Re: Panel Reference Number 2016WES006 – Dubbo – PP 2016_Dubbo_005_00 – Daisy Hill

Panel Reference Number: 2016WES006 – Dubbo – PP_2016_DUBBO_005_00 – Daisy Hill, Dubbo

**WESTERN REGION PLANNING PANEL, PUBLIC EXHIBITION OF DAISY HILL PLANNING PROPOSAL
– DUBBO REGIONAL COUNCIL SUBMISSION**

Figure 1. SSM interpretation of conceptual model used by Envirowest Consulting (2017b, 2018) for groundwater of proposed Daisy Hill Estate.

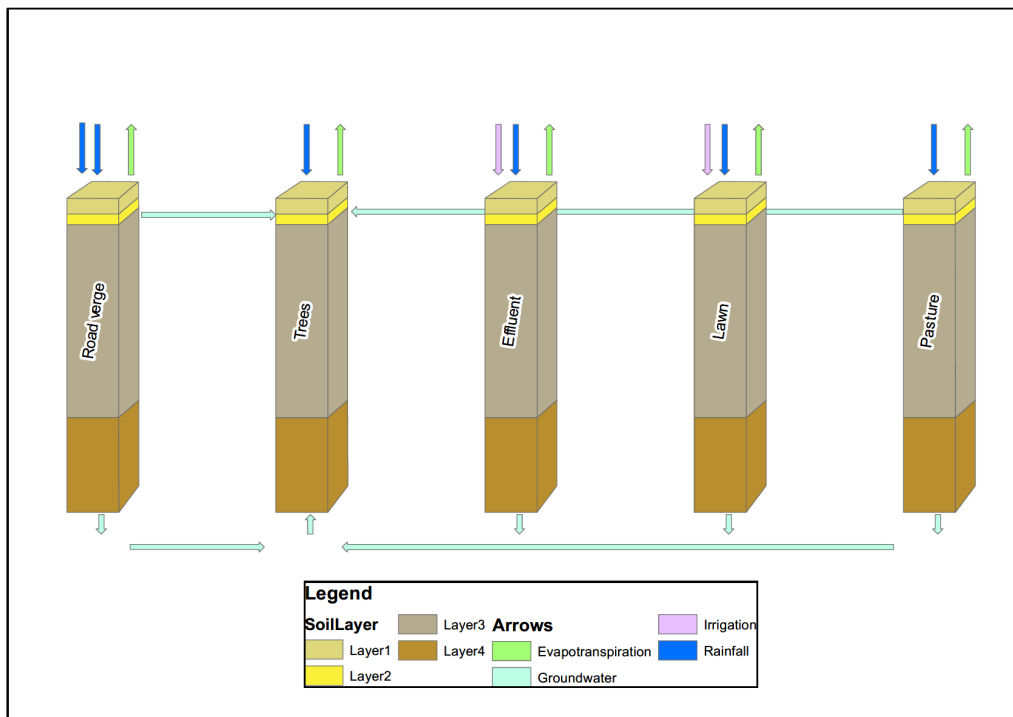
The Soilwater (2018) and EMM (2018) reviews indicate that the conceptual model of a number of soil domains represented by 1-dimensional water flow models and linked by lateral flow (Figure 1) is an appropriate way to characterise groundwater in the proposed Daisy Hill Estate. We agree that this conceptual model is an appropriate one, but not the way it has been applied.

Job Code: GW37
 Map Printed: 2019
 Salinity: [REDACTED]
 Map of Lot Boundaries and EM31 S

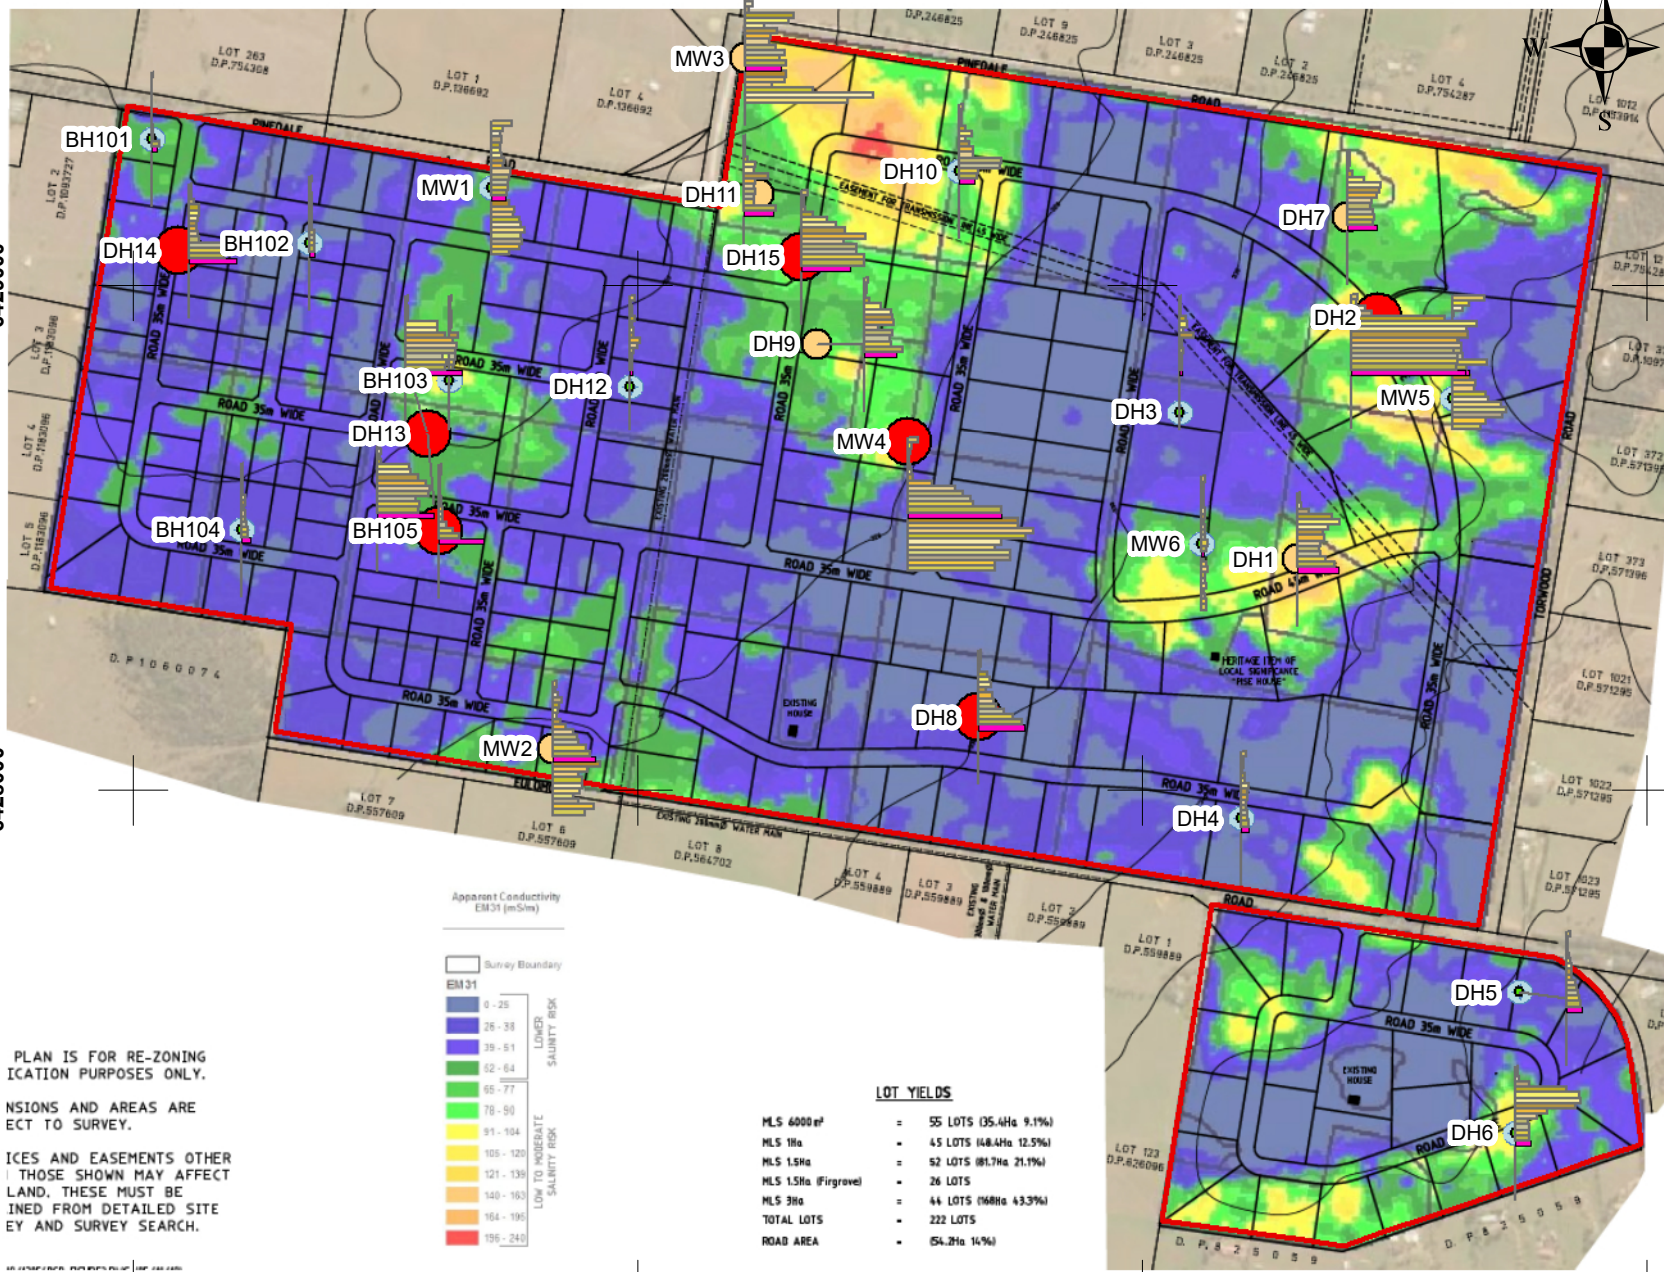
The area of low to moderate salinity risk in the Master Plan (Heath Consulting Engineers, 2019) has increased to approximately 25% of the total area. These areas are depicted as the green, yellow and orange areas in Map 2. Some of these areas are described as the contact zone between the Pilliga Sandstone and Purlewaugh Formation geology in the Salinity Management Strategy (Envirowest Consulting, 2018b) and Vegetation Management Plan (Soilwater, 2019), but not mapped in the suite of reports.

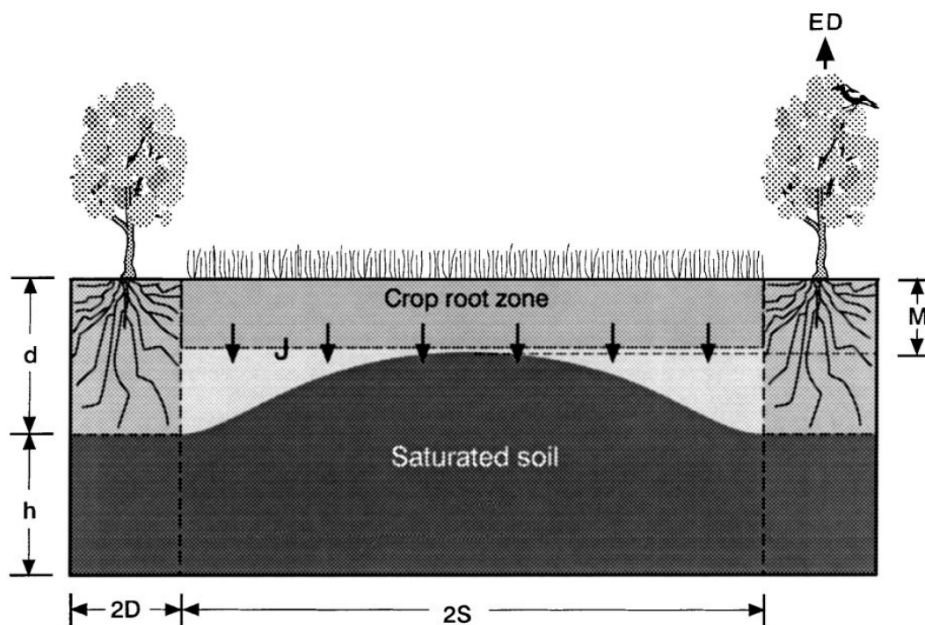
These estimates indicate that the proposed tree plantings could lower the water table sufficiently to minimise the area of shallow groundwater within the proposed Daisy Hill Estate. However, there will be some deep drainage beneath the land as a shallow water table is required to provide the force to move water towards the trees. Furthermore Benyon *et al.*, (2006) in a review of data from 21 Australian sites found that trees could lower groundwater levels to around 6 m. As a result, trees will not take up significant groundwater in areas represented by Figures 3 to 5 and Envirowest Consulting (2018a) until groundwater levels rise from the current 12 and 14 m to shallower than 6 m.

The salinity profiles of DH3, DH4, DH5, DH12, BH101, BH102, BH104, MW1 and MW6 have low E_C from the surface to 6 m (Map 2), indicating that there has been recharge beyond this depth (Figure 5). It is likely that this deep drainage will continue if groundwater levels in these areas rise to shallower than 6 m as would be required to push groundwater towards trees as shown in Figure 3.

Figure 4. Critical EM31 apparent electrical conductivity (ECa) above which soil salinity measured as electrical conductivity of saturated extract (ECe) was greater than 2 and 4 dS/m across proposed Daisy Hill Estate.

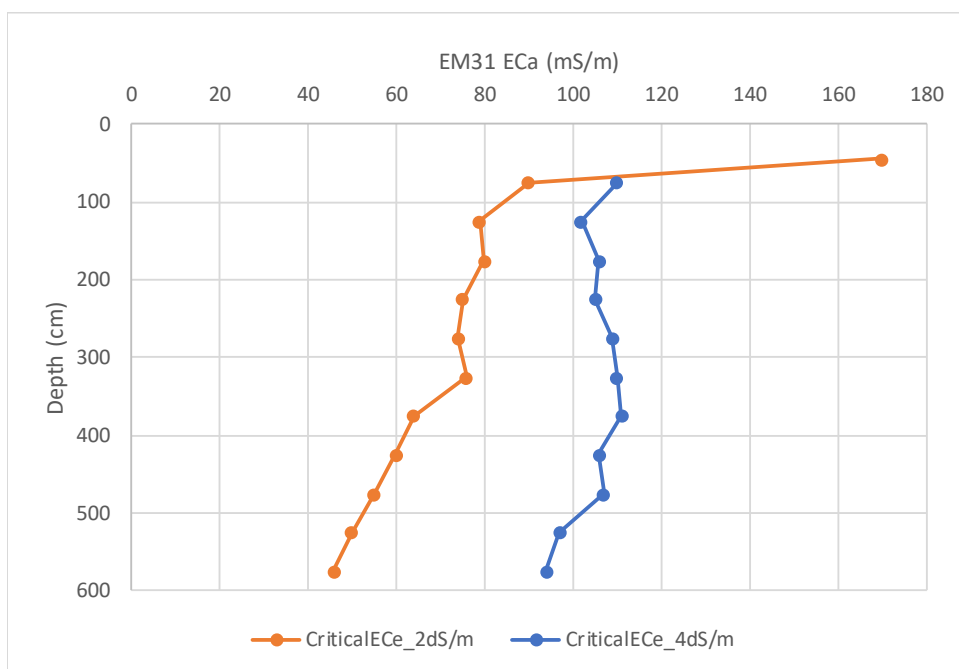
This indicates that salinity would be expected to be low enough to not restrict root growth to 6 m where EM31 ECa is less than about 50 mS/m (blue areas in Map 2). Similarly, salinity would be expected to restrict root growth of salt sensitive plants in the 50 to 550 cm layers of areas with EM 31 ECa greater than 100 mS/m (yellow, orange and red areas in Map 2).

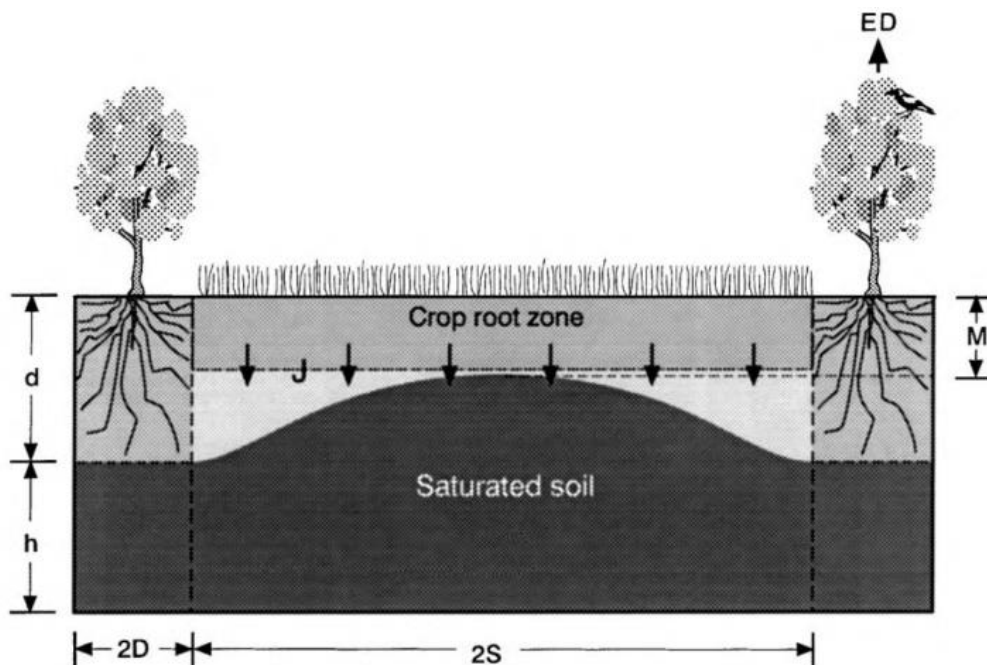
- The SSM review of Daisy Hill Groundwater and Salinity Modelling found;
 - EnviroWest propose the concept that vegetation planted along the subdivisions roads will intercept groundwater, both at depths greater than 6m and uniformly. SSM cite research by Stirzaker which disproves both concepts. Tree zones will be able to intercept groundwater only shallower than 6m, and the zones between plantings (i.e. the residential lots) will experience significantly shallower groundwater than that once this state has been achieved as shown by the following diagram (taken from the SSM review).

- EnviroWest propose that tree plantings alone will lower the water table sufficiently to minimise shallow groundwater within the estate. Vegetation planting along roadways will likely lower groundwater along the planted corridors (roadways) but, as shown above will not decrease groundwater levels at distance (i.e. on the residential lots). Furthermore in order for groundwater to reach levels at which tree plantings will impact the groundwater level that groundwater must rise to <6m. In order to achieve
